**Moorhead Area Public Schools
New Elementary School
Moorhead, Minnesota**

Project No. 15-025

Bid Date & Time: Thursday, April 21, 2016 at 2:30pm
Date: April 18, 2016

ADDENDUM No. 2

ENLARGED PLAN - AREA C

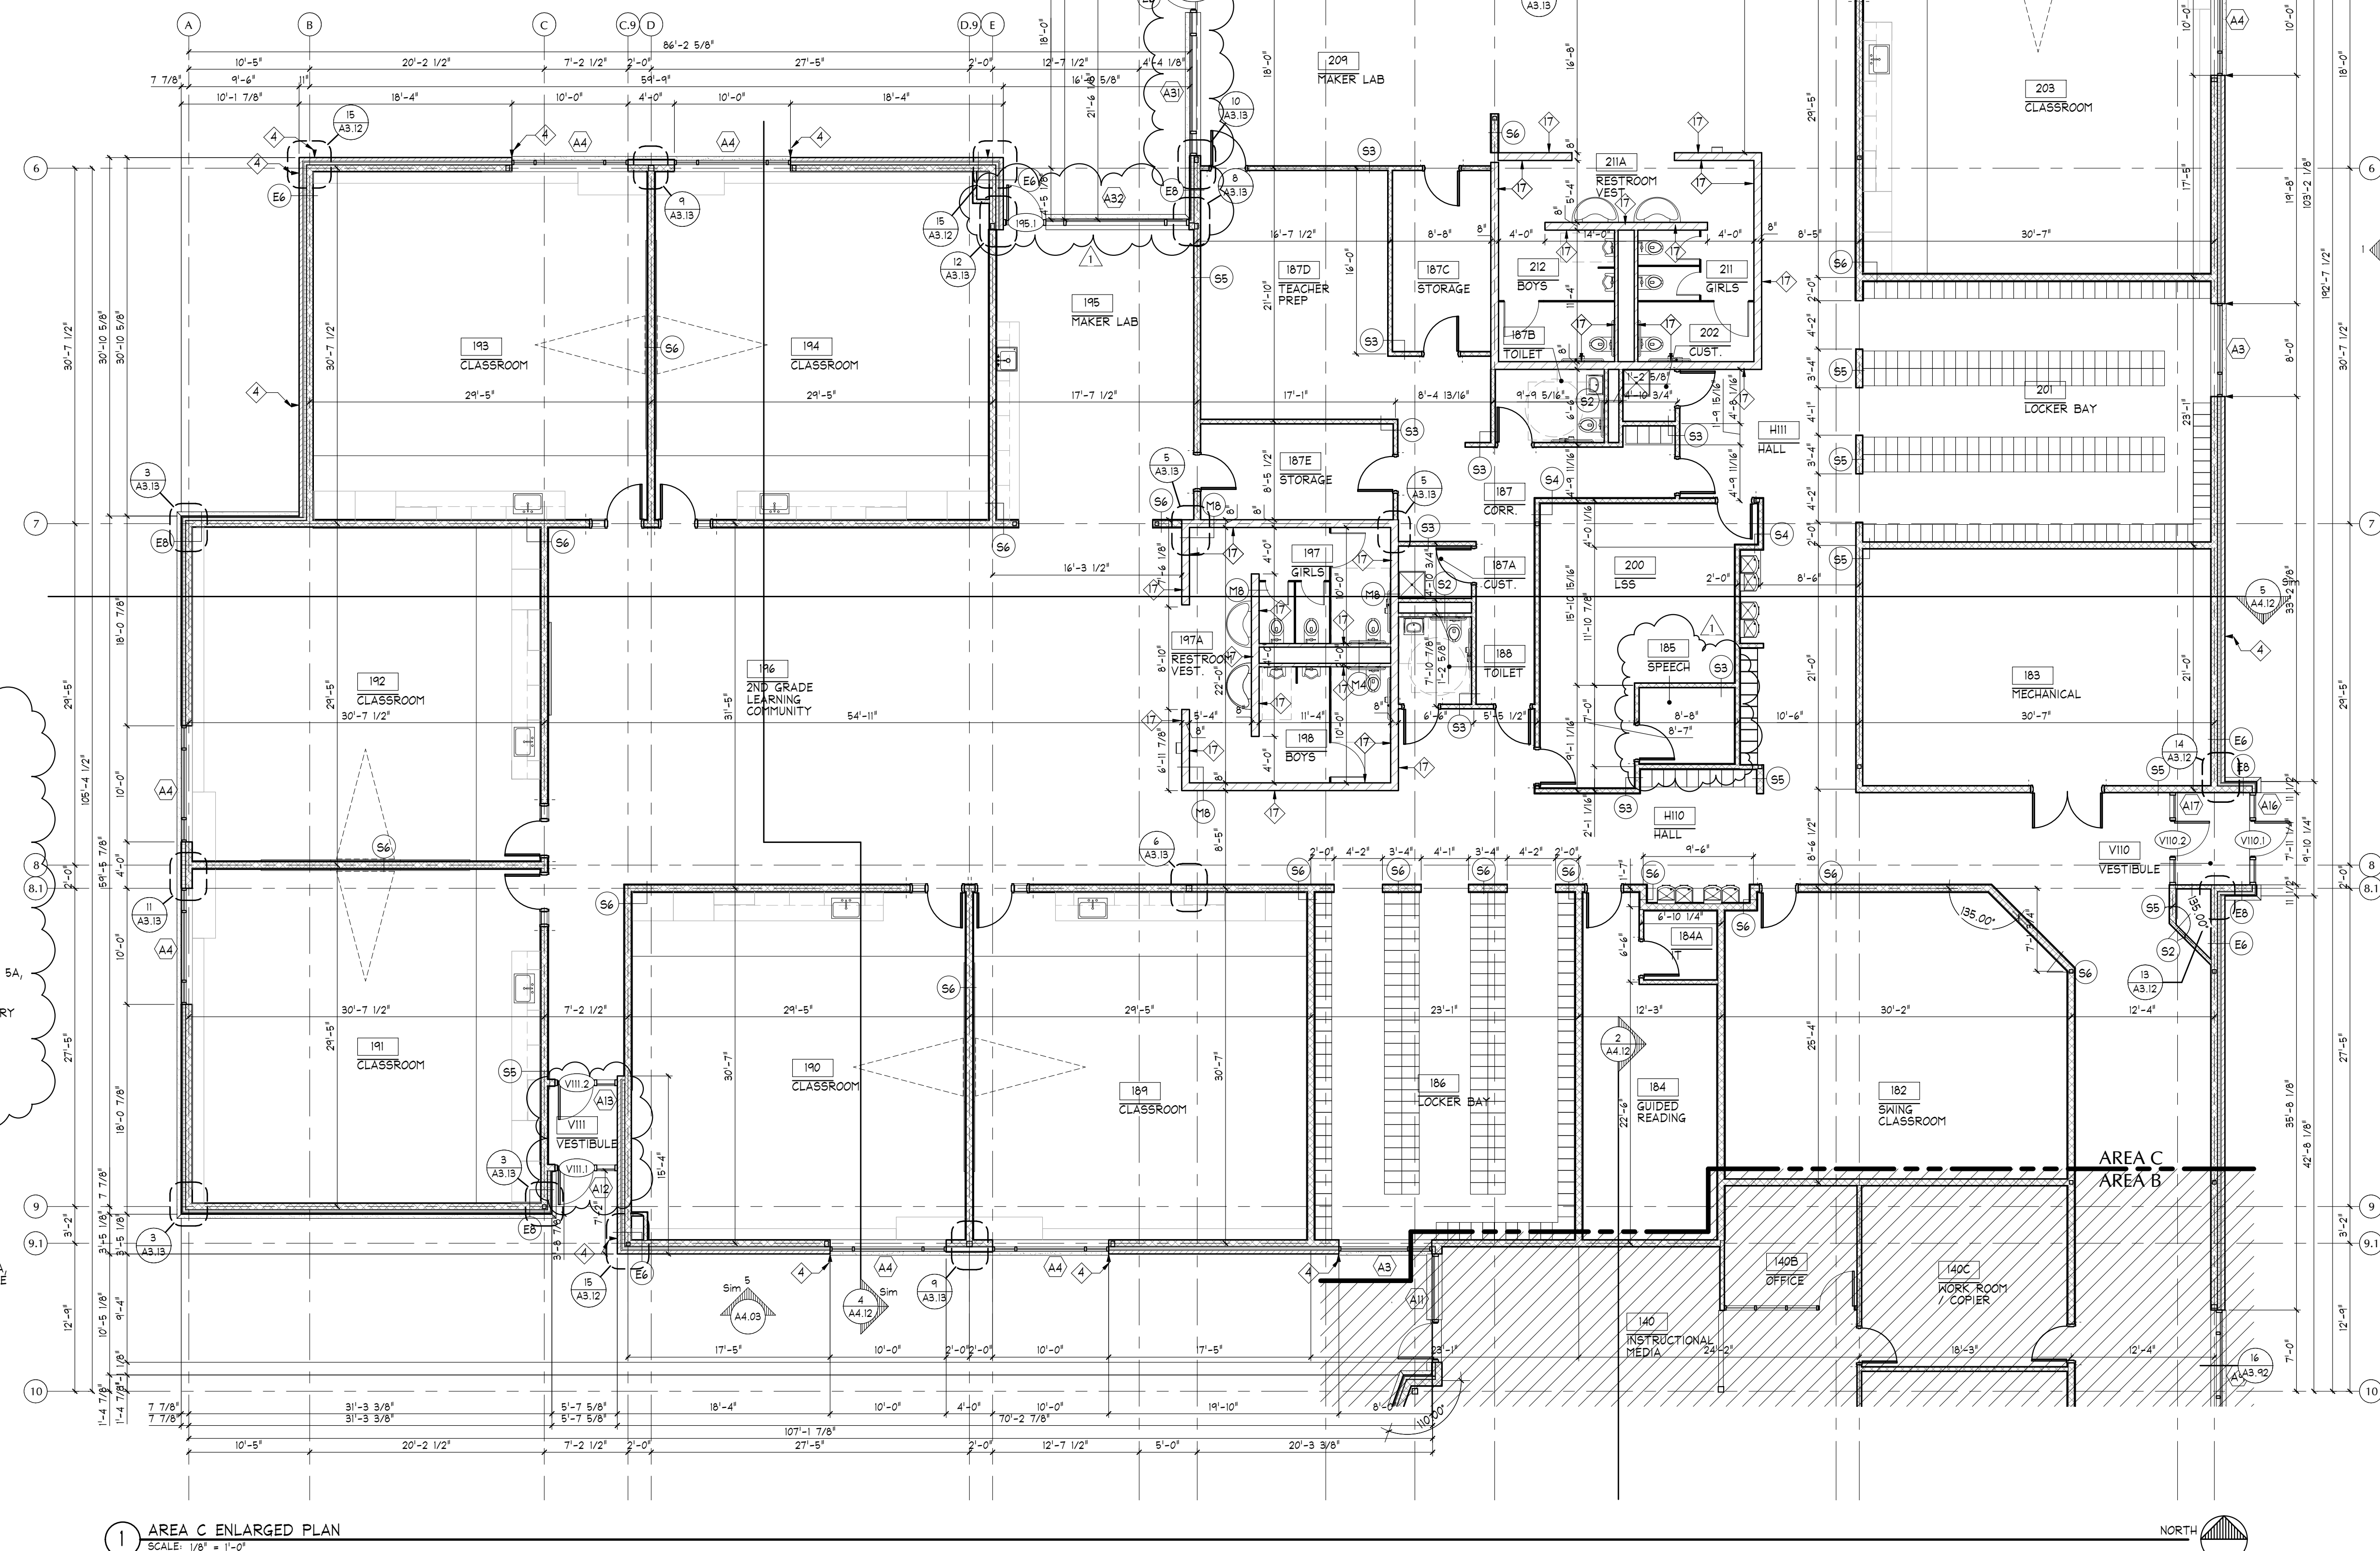
Sheet A3.12 – Enlarged Plan – Area C

1. Insert revised plan detail 16/A3.12.
